# DRB MEETING

**PRELIMINARY PLAT REVIEW  
PR-002-23**

Cline Road, LLC, hereafter referred to as Applicant, is requesting Preliminary Plat review for a 15-lot 14 unit Planned Unit Development (PUD) subdivision. The parcel is located at Cline Road and Horseshoe Barn Road and consists of ±94.49 acres. The parcel is located within the AR-1 zoning district.

ROAD PLAN & PROFILE STA. 00+00 - 09+00  
CLINE ROAD LLC  
CLINE ROAD  
GEORGIA, VERMONT

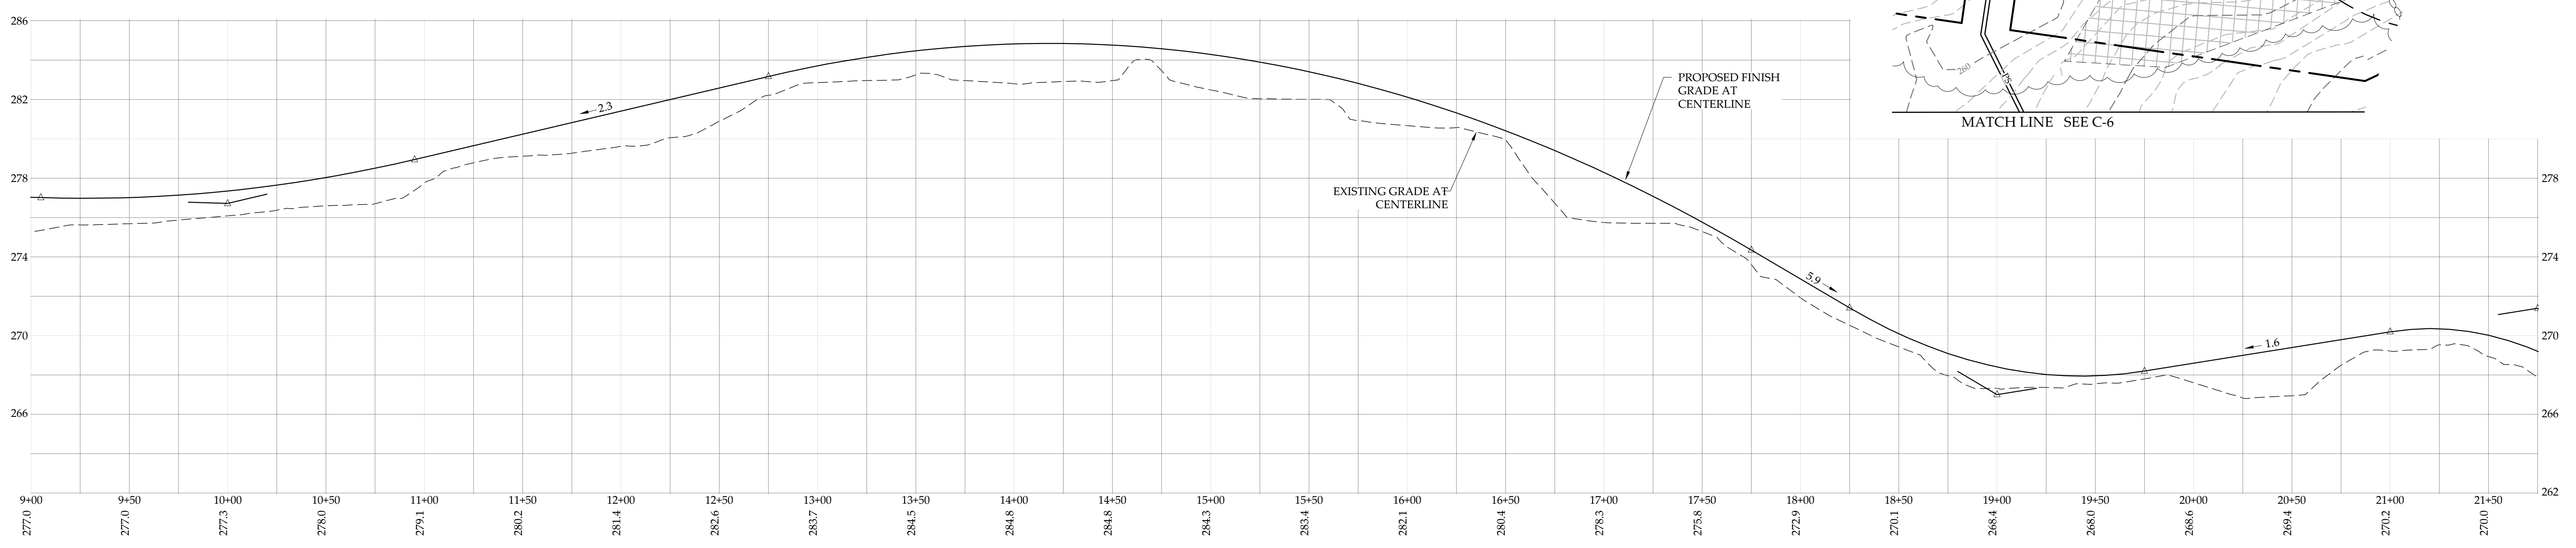
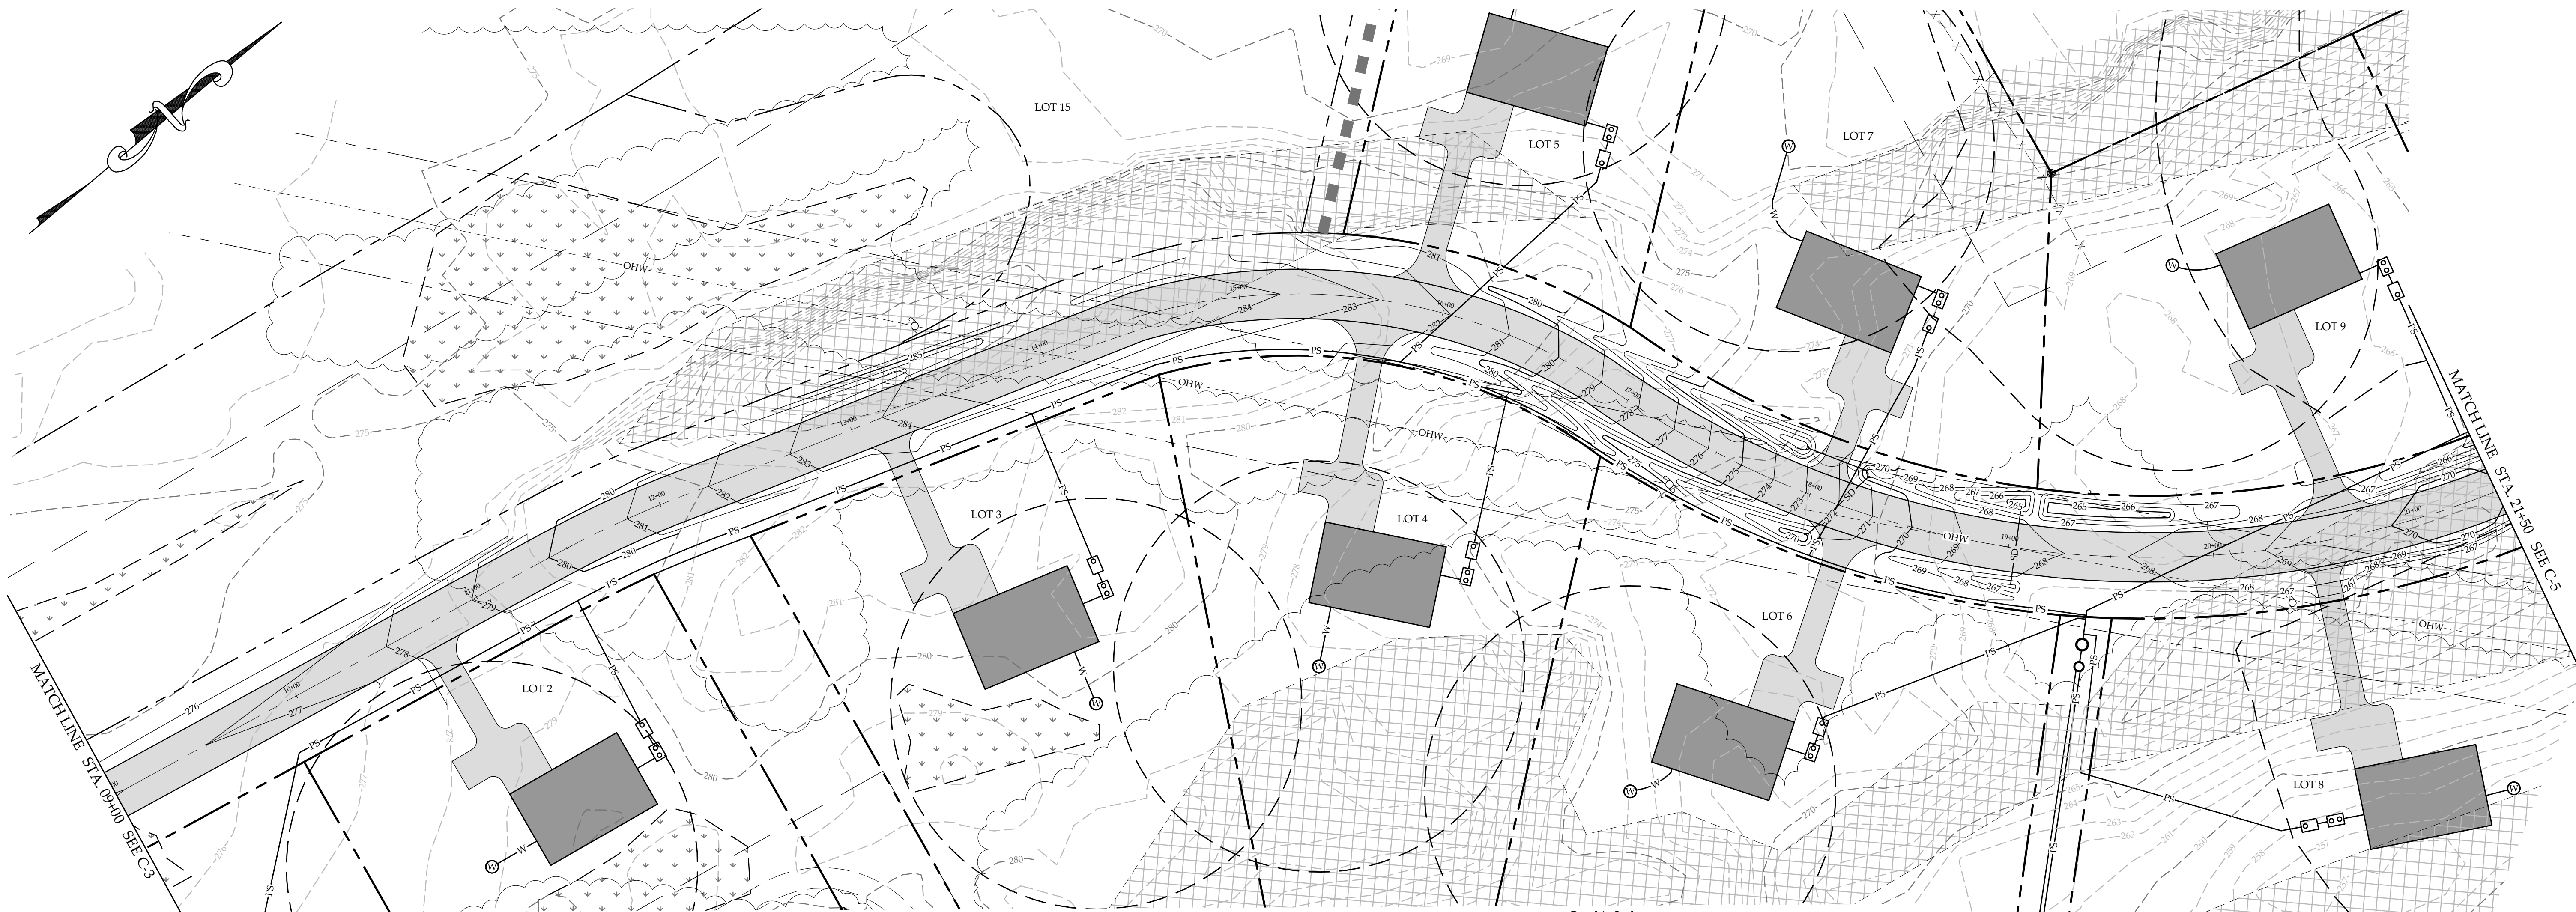
**Section 7.11 Public and Private Road Standards** – Applicant will utilize plans C-3, C-4 and C-5 Road Plans and Profiles and shall follow the Town of Georgia’s Private Road and Driveway Standards.

1  
C-8  
**STORMWATER PLAN**  
SCALE: 1" = 20'  
Graphic Scale  
20 0 20 40 80 feet

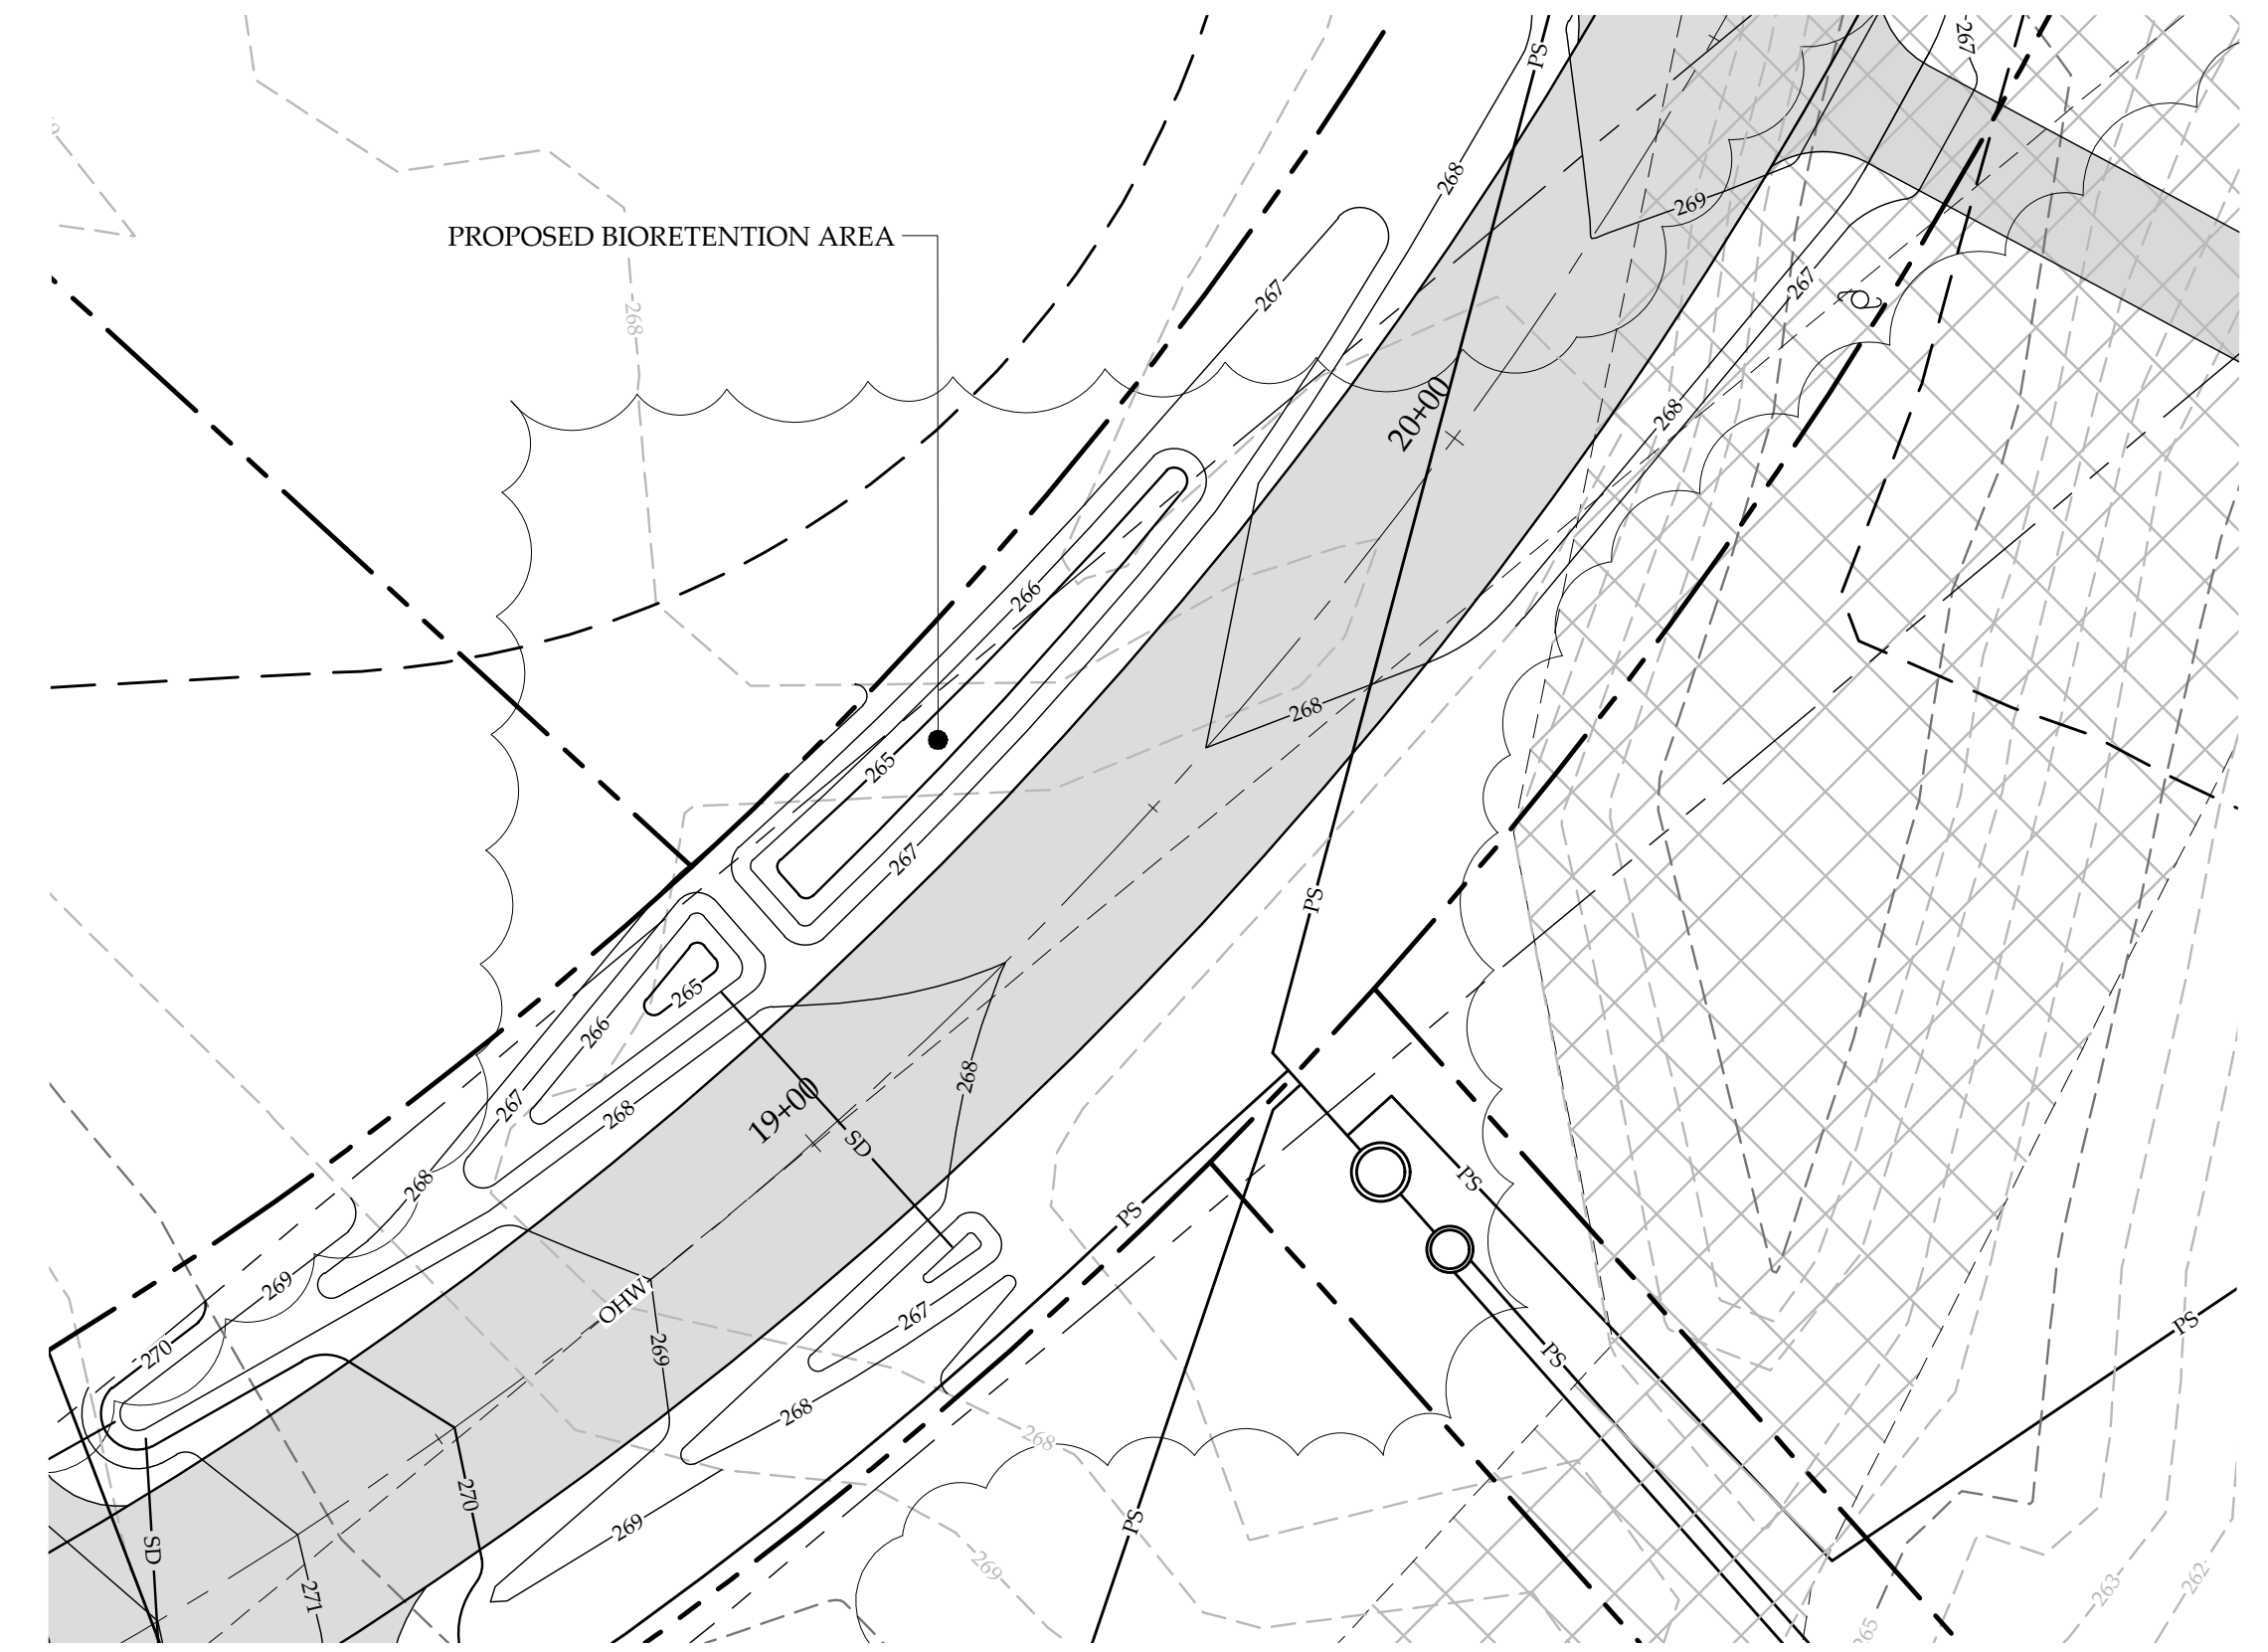
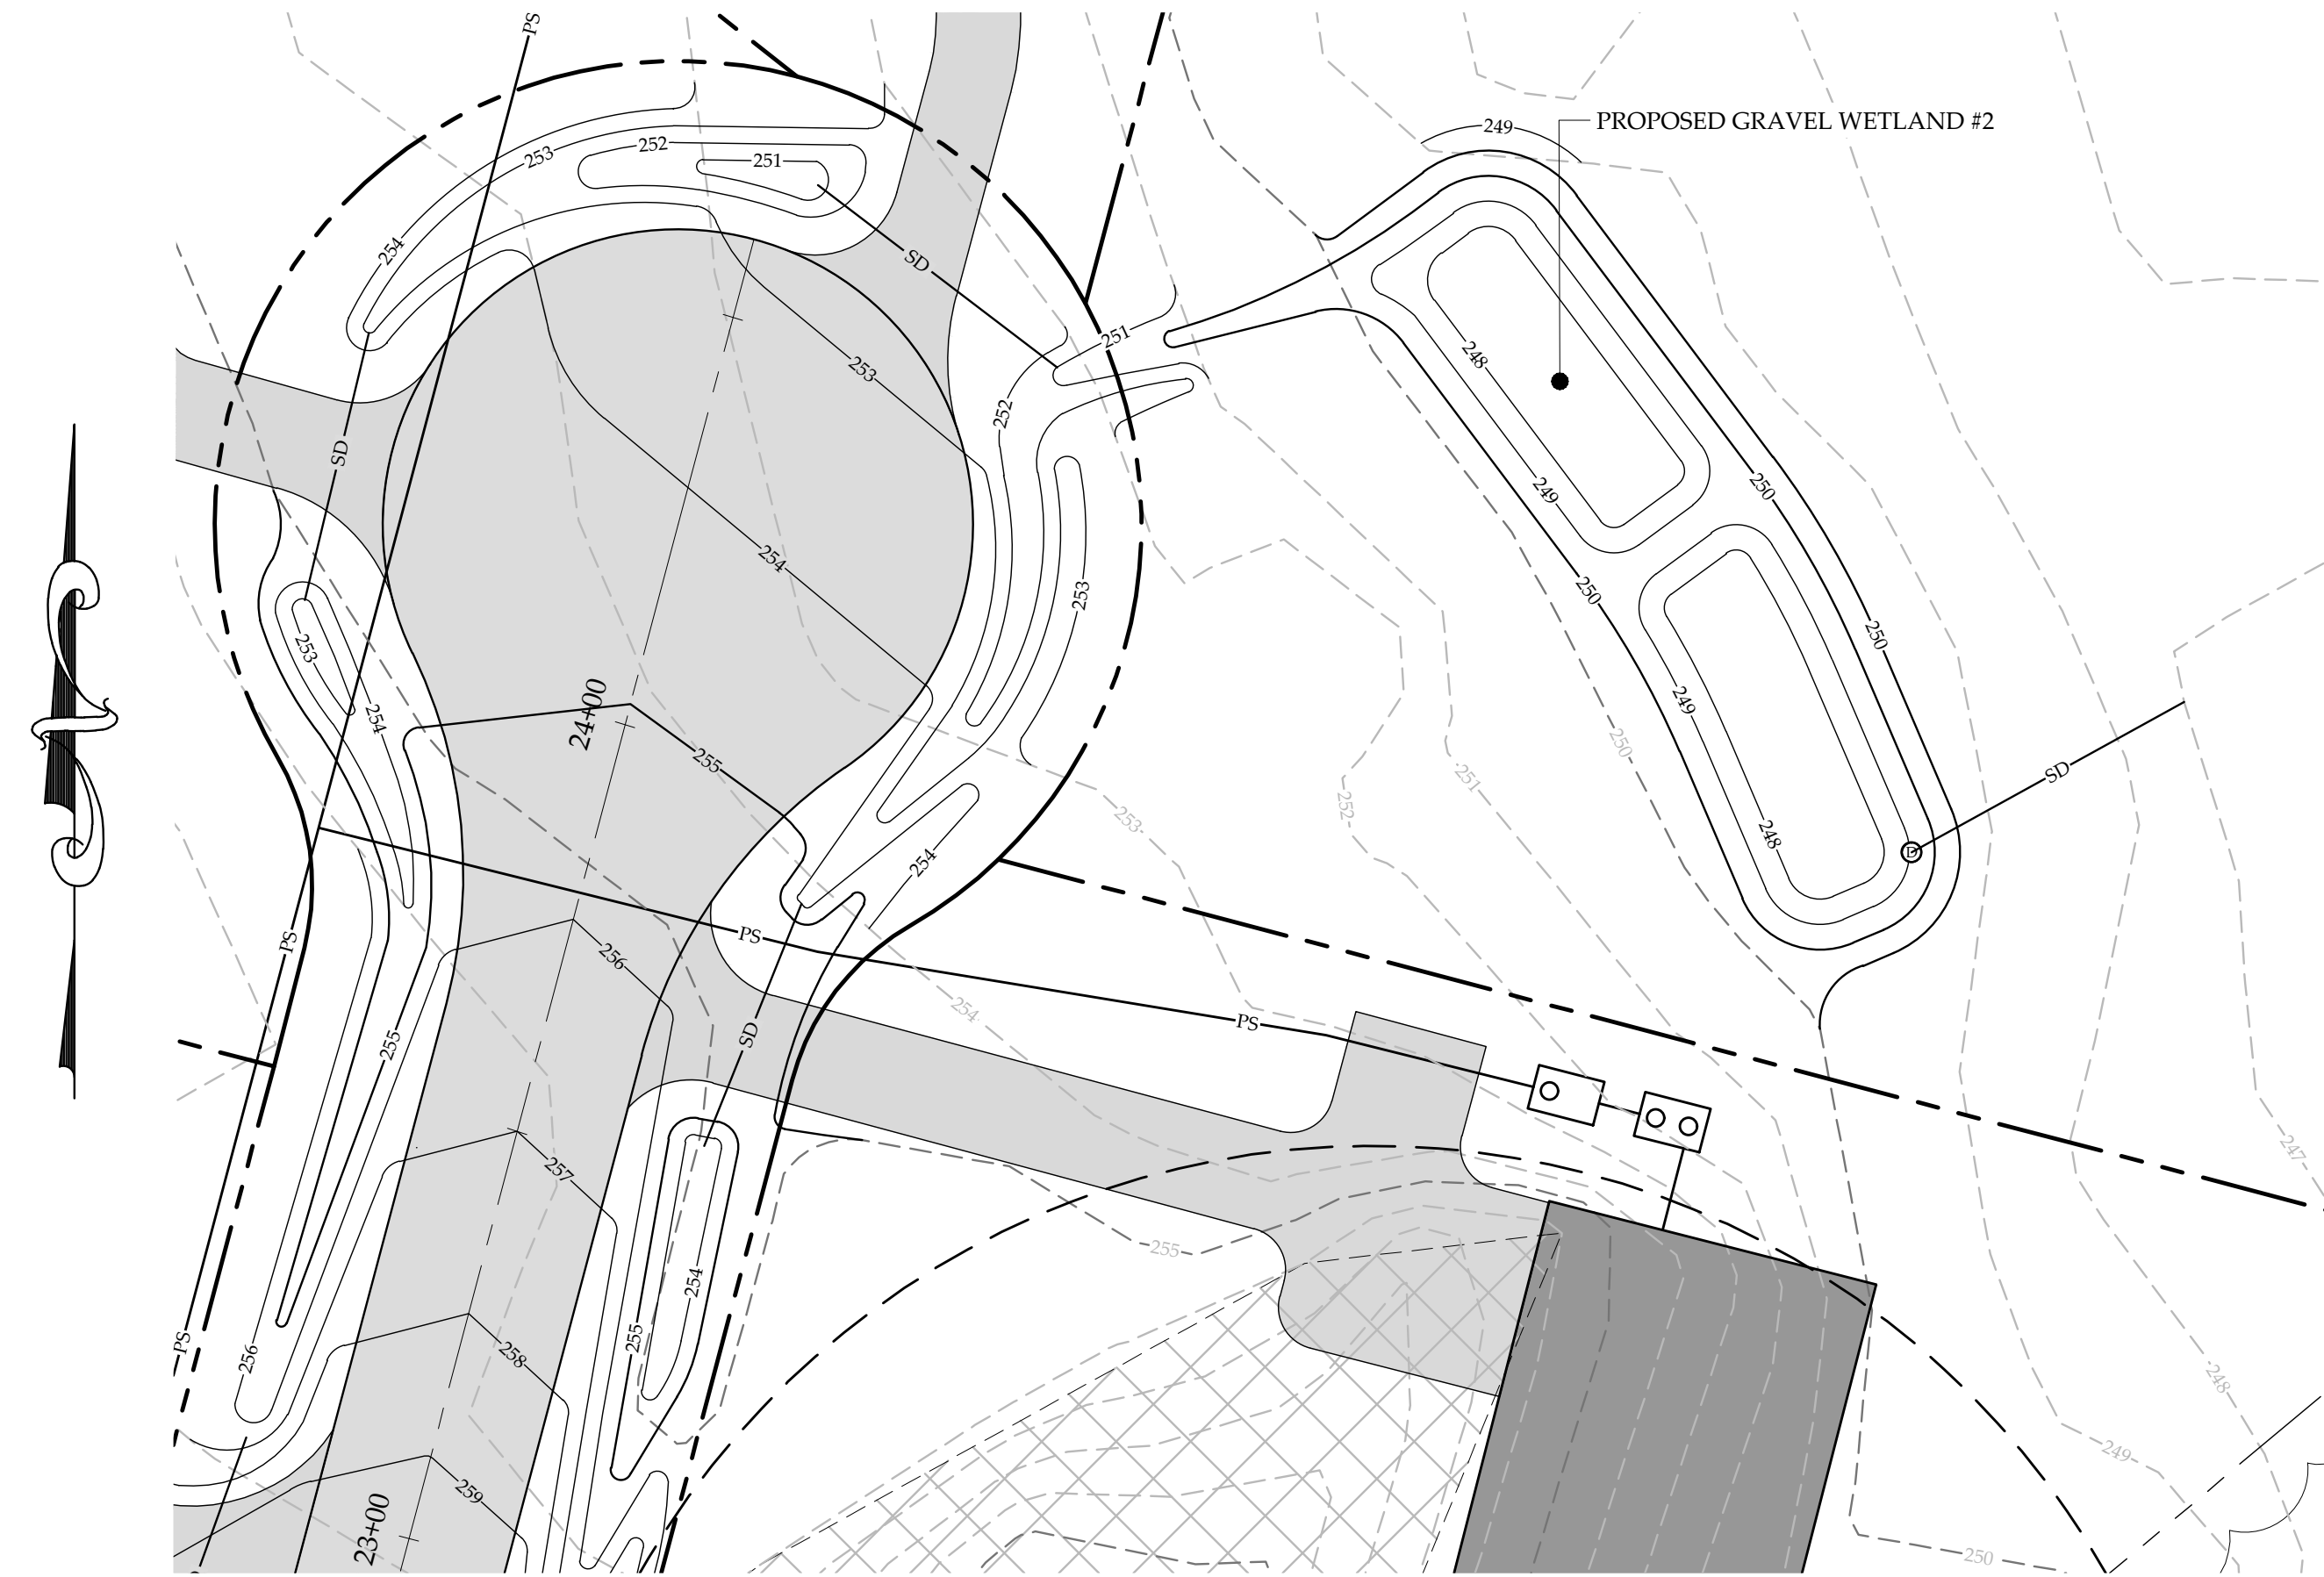
**Section 7.13 Stormwater** – Referenced in the plans C-8 and C-9, Stormwater Plans and Details.
